UNITED STATES PATENT AND TRADEMARK OFFICE

APPLICATION NO.	FILING DATE	FIRST NAMED INVENTOR	ATTORNEY DOCKET NO.	CONFIRMATION NO.
10/801,265	03/16/2004	Jean-Paul Bonnet	1055-04	4747
35811	7590	01/23/2006	EXAMINER	
IP GROUP OF DLA PIPER RUDNICK GRAY CARY US LLP			RODRIGUEZ, WILLIAM H	
1650 MARKET ST			ART UNIT	
SUITE 4900			PAPER NUMBER	
PHILADELPHIA, PA 19103			3746

Office Action Summary	Application No.	Applicant(s)	
	10/801,265	BONNET ET AL.	
	Examiner	Art Unit	
	William H. Rodriguez	3746

FINAL REJECTION

FIG. 1
PRIOR ART

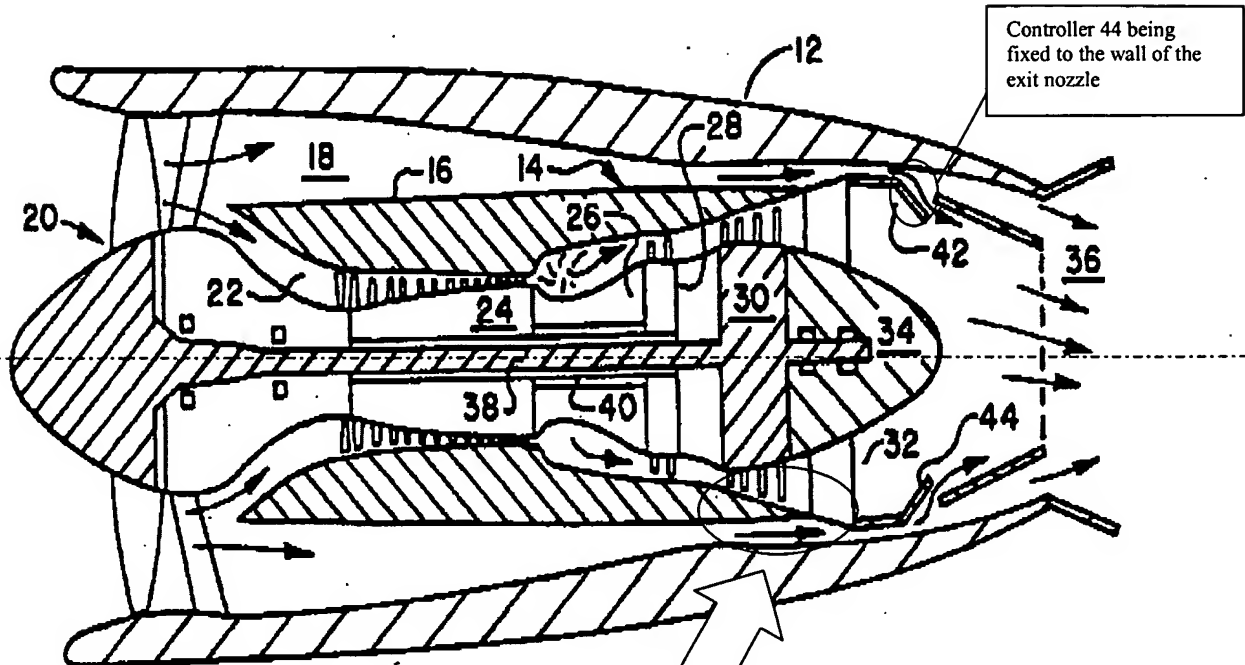
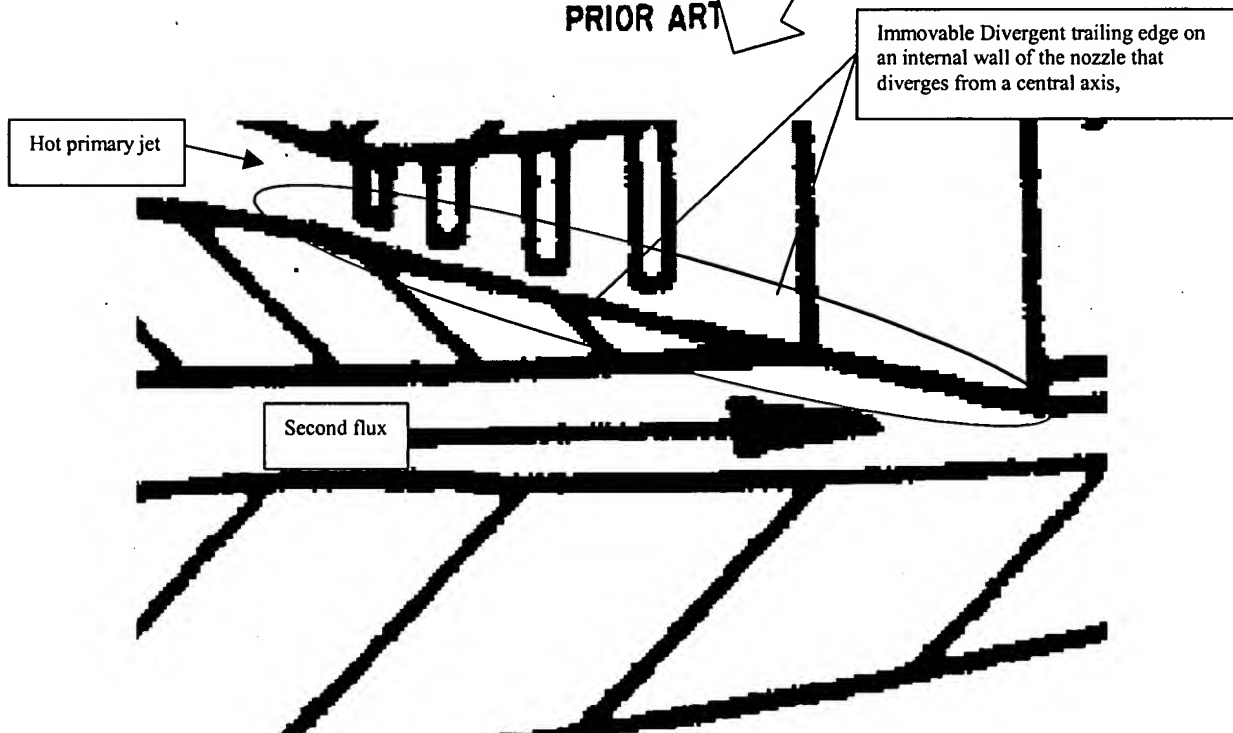
The phrase “*..enables control of passage of the primary jet from a separated state to a reattached state and vice versa*”, recites desired expected results of the controller but does not limit or add any patentable weight to the claim.

Since the claim does not positively recite any structural limitations about the controller but just its desired expected results, the controller recited in the claims does not differentiate the claimed apparatus from a prior art apparatus satisfying the structural limitations of the claims, as is the case here. Basically, all applicant is claiming is a controller fixed to a wall.

McAndrews teaches that the primary jet is separated from a wall (separated state) when the controller is activated (as shown in Figure 1) and the primary jet is reattached to the wall (reattached state) when the controller is deactivated. Therefore, the primary jet controller 44 of **McAndrews** performs the desired expected results as expected by the controller of the invention, that is, it (44) enables control of passage of the primary jet from a separated state to a reattached state and vice versa.

With respect to claims 15 and 29, **McAndrews** teaches an engine having a device for controlling propulsive gas mixing at an outlet of said engine, wherein propulsive jets are composed of a hot primary jet exiting from a nozzle of the engine and a secondary flux flowing between an external wall of the nozzle and an internal wall of the engine, the device comprising: a divergent trailing edge/immovable trailing edge on an internal wall of the nozzle that diverges from a central axis extending along the jet engine and generates conditions of a minimal separation of the primary jet from the internal wall; and a primary jet controller that enables control of passage of the primary jet from a separated state to a reattached state, and vice versa; the controller being fixed to the wall of the exit nozzle relative to the primary jet; and the divergent trailing edge being in a fixed position with respect to the wall of the nozzle. See particularly **Figure 1** of **McAndrews** above.

With respect to claim 16, **McAndrews** teaches that controlling the separation of the primary jet is periodic (elements 42, 44 open and close periodically depending on the mode of operation). See particularly **Figure 1** of McAndrews above.

With respect to claims 23 and 24, **McAndrews** teaches that the controller is arranged on a part of the circumference of the internal wall of the nozzle and on a part of the external wall of the nozzle. See particularly **Figure 1** of McAndrews above.

With respect to claim 25, **McAndrews** teaches that control of the separation of the primary jet is implemented at the trailing edge. See particularly **Figure 1** of McAndrews above.

With respect to claim 26, **McAndrews** teaches that control of the separation of the primary jet is implemented to generate either a symmetrical flow or an antisymmetrical flow at the outlet of the engine. See particularly **Figure 1** of McAndrews above.

With respect to claim 27, **McAndrews** teaches that the trailing edge has an angle with the wall of the nozzle between about 10 and about 30 degree as shown in **Figure 1** of McAndrews above.

With respect to claim 28, **McAndrews** teaches that the wall of the nozzle is convergent upstream of the trailing edge. See particularly **Figure 1** of McAndrews above.

On page 7 of the response, applicant argues that McAndrews divergent trailing edge is not stationary but movable. Examiner respectfully disagrees because as clearly shown in Figure 1 above, McAndrews divergent trailing edge is stationary, the controller 44 is the one that moves from an activated position to a de-activated position. See particularly **Figure 1** of McAndrews above.
